CERTIFICATE OF APPROPRIATENESS PLACARD

314 E CABARRUS STREET

PRINCE HALL

- Install HVAC units and wood screening fence

01 WEST ELEVATION
1/4" = 1'-0"

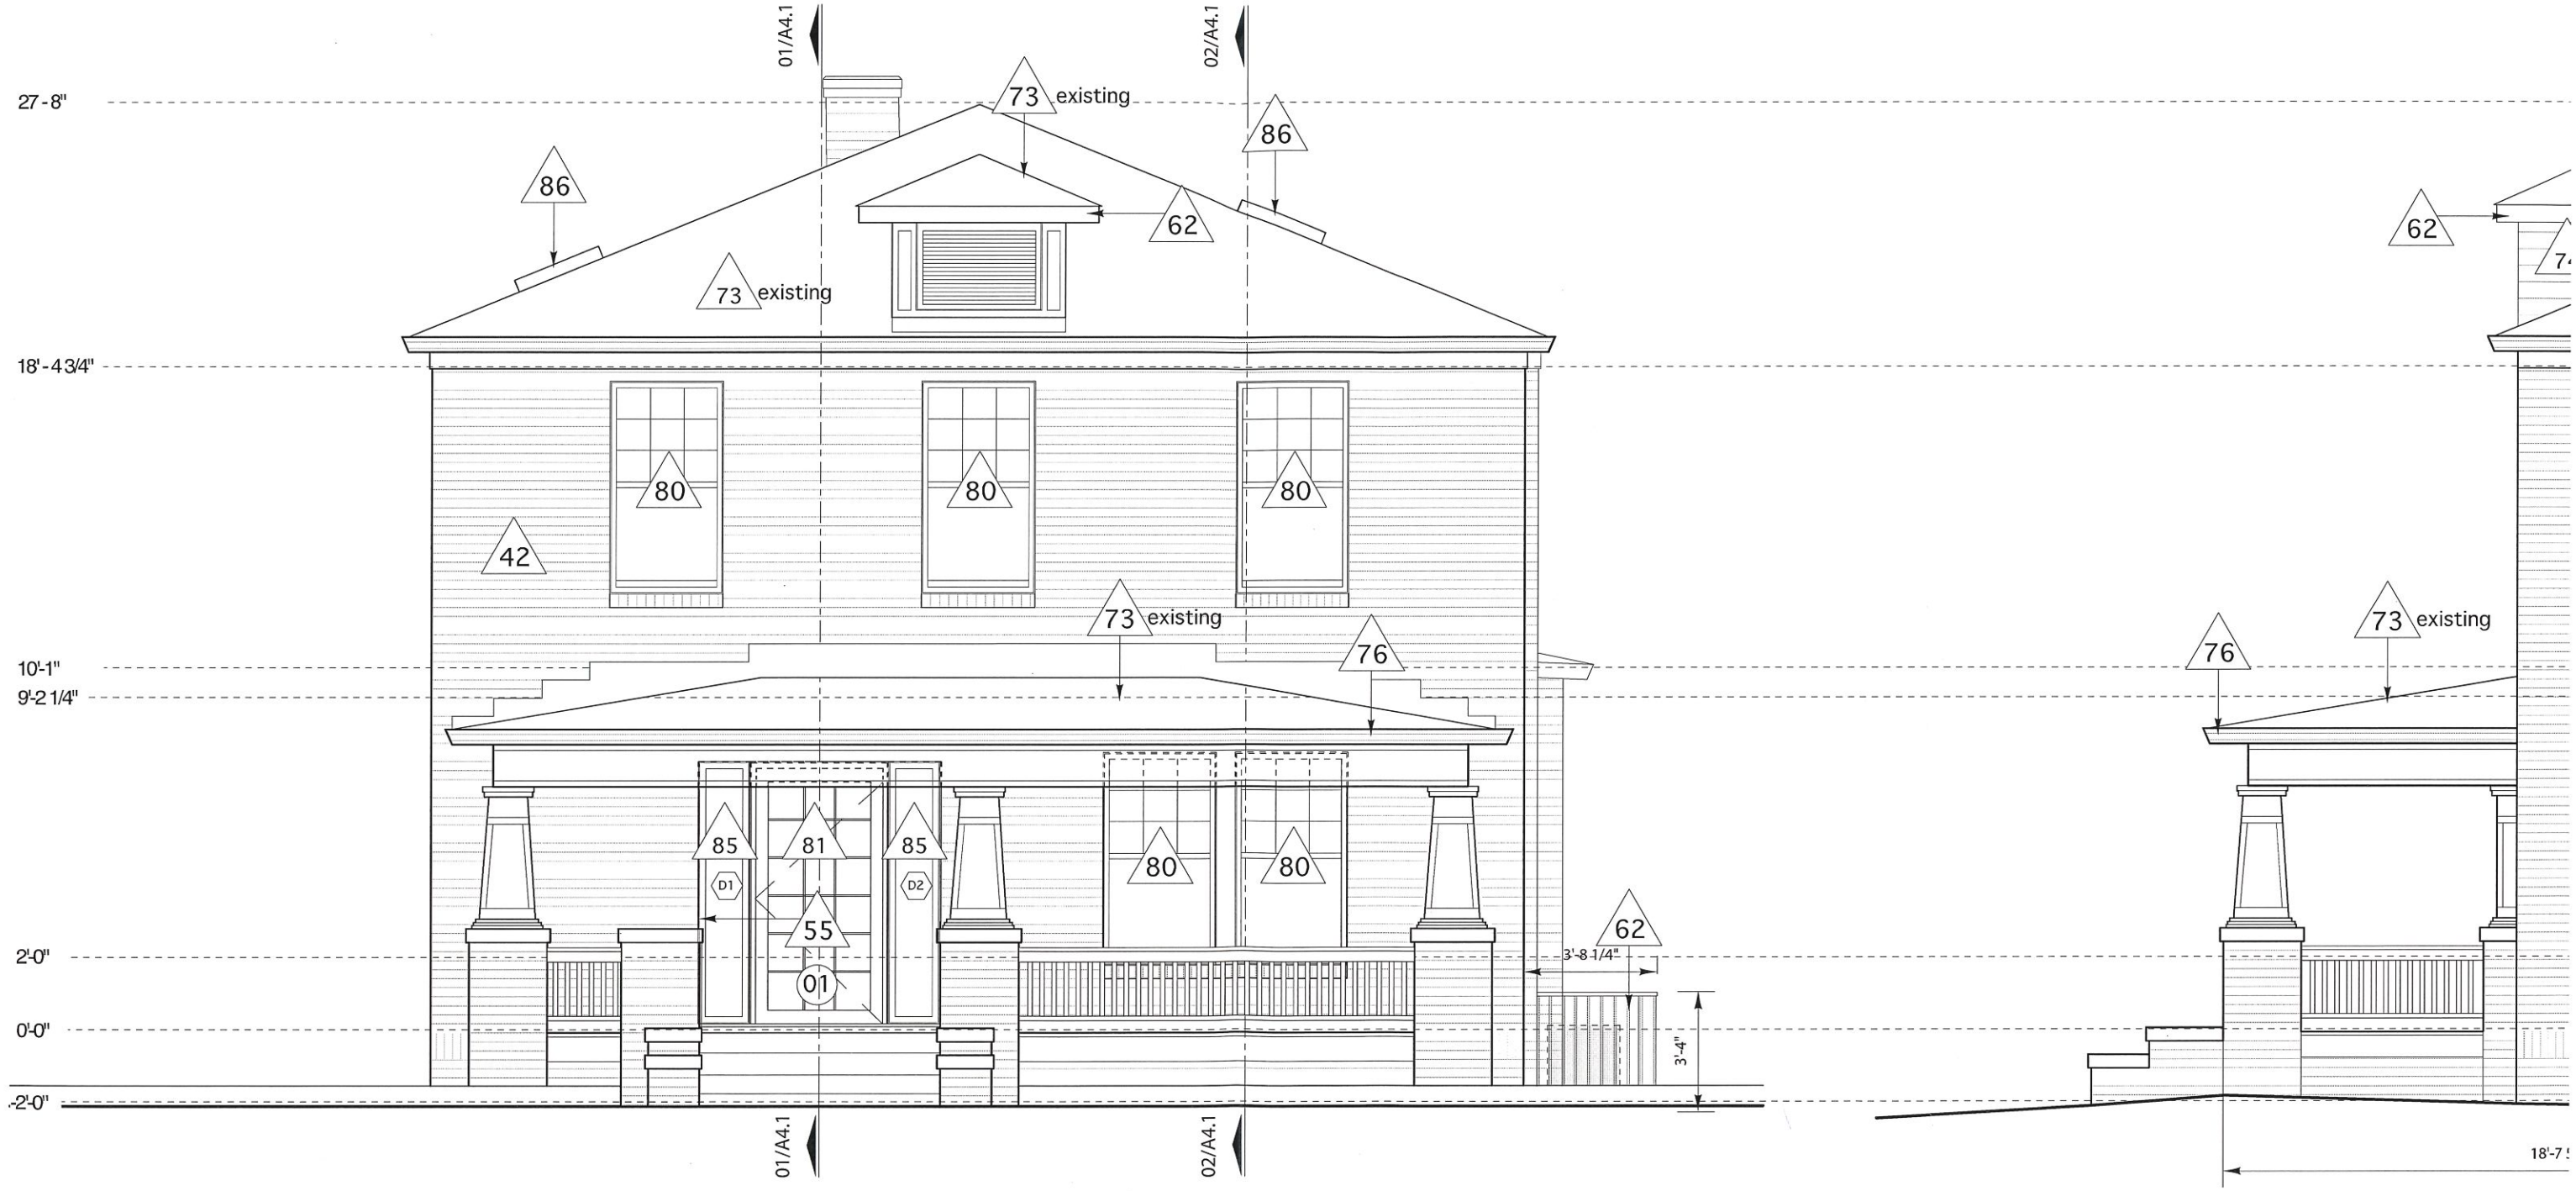
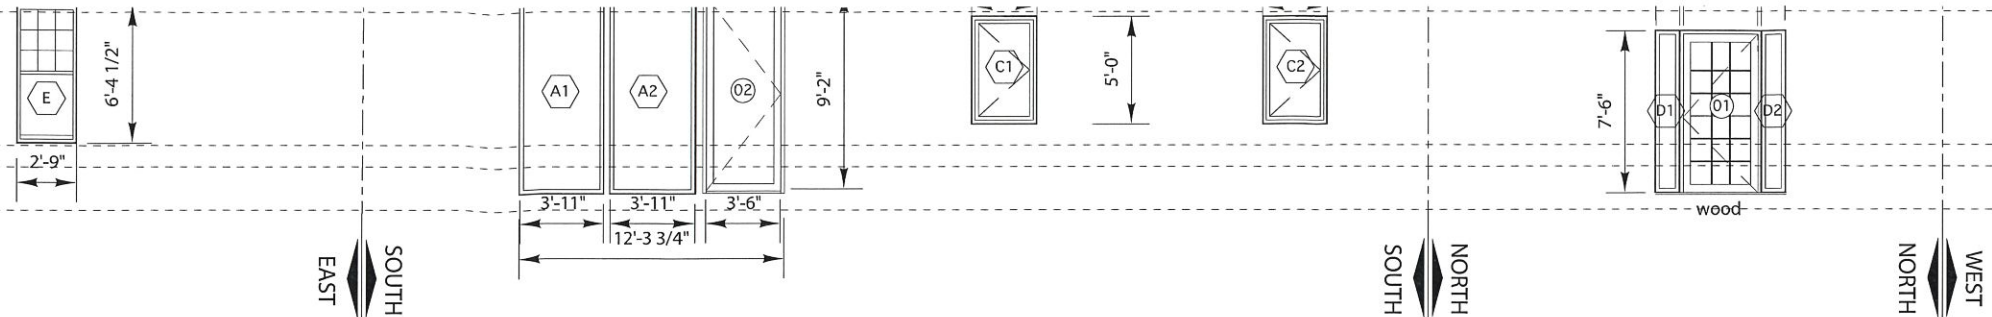
- How tall will the fence be? Note that staff only has authority to approve fences 42" and lower. **40"**.
- Please provide an image/drawing of the proposed fence design reflecting a 42" height (presuming that is your proposed height). **See attached - ~~Horizontal~~ stained and sealed slats to match deck skirt.**

- The height of the proposed wood screening around the HVAC units is appropriate. **Great!**
- The proposed mounting method is also. **Great!**
- The stained horizontal slat fencing, however, is not something I can approve as staff. It is an atypical fencing configuration that does not clearly meet the guidelines. Additionally, the commission has specifically horizontal slat fencing in a rear yard on Oakwood.

Staff can only approve a vertical screening fence with a traditional appearance. Please revise or convert the COA to a Major Work.

Thanks. Please provide details on the fence – an enlargement of the proposed fence with the material dimensions should suffice. What's the width of the pickets, corner posts, top rail, space between pickets, etc.

The idea is to match the deck skirt side of steps that has been approved. If vertical is the only permissible option I will revise.

The deck skirt approved for side of deck steps at RHDC are horizontal wood slats. See 01 A3.2 at the far right side.

Understood - would like to avoid that...see revised.

Attached is the blow up requested. Let me know if I need to add anything to it.

40" fence

SURVEY ADDRESS:
314 EAST CABARRUS STREET
RALEIGH, NC 27609

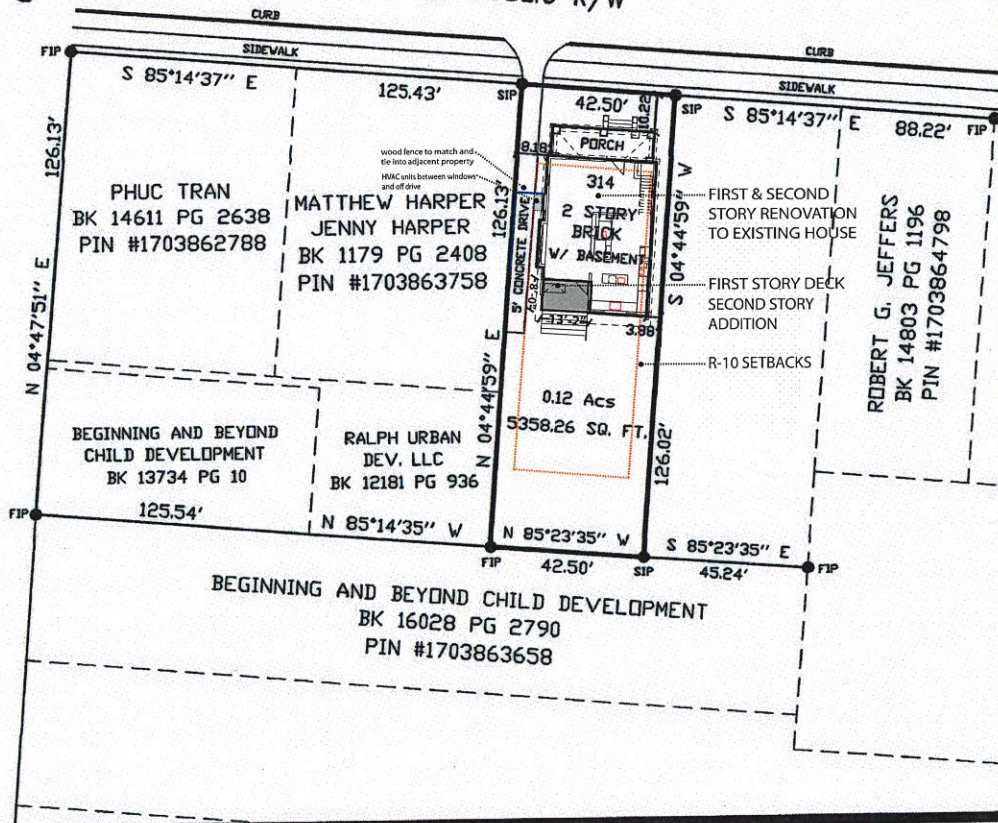
Located fence to screen HVAC units - Fence will have approximately 8' of EW run and 24' NS run and tie into adjacent property fence [see attached plot plan and IMG 1, IMG 3]

[IMG 1 - NTS]

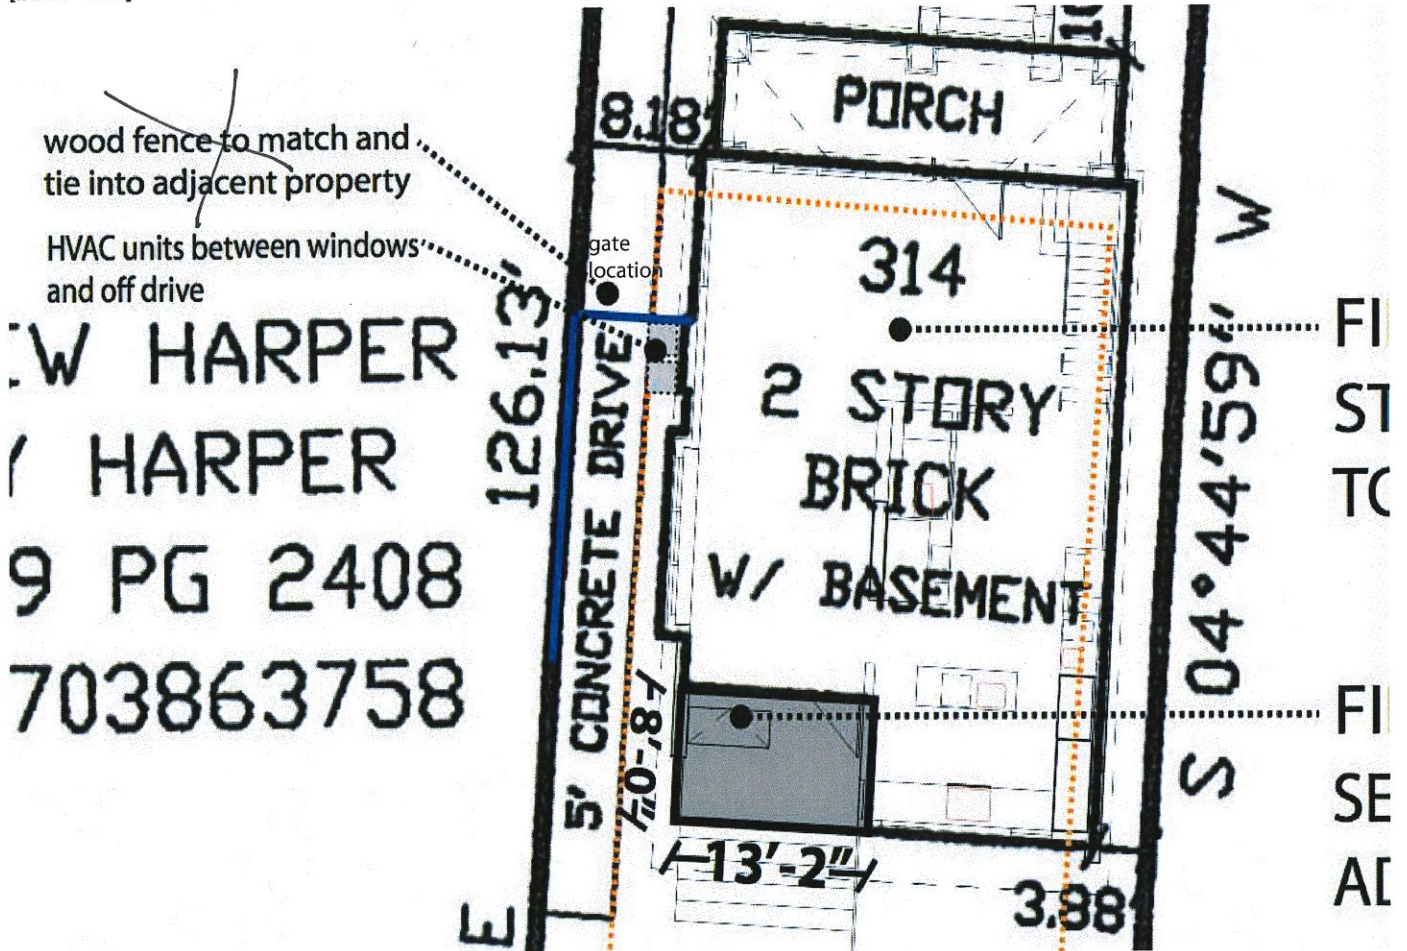
Locate two new HVAC units on west elevation of house between windows and adjacent to 5' access drive. [see attached plot plan, IMG 1, IMG 3]

Design of wood fence will match adjacent property fence. [see IMG 2]
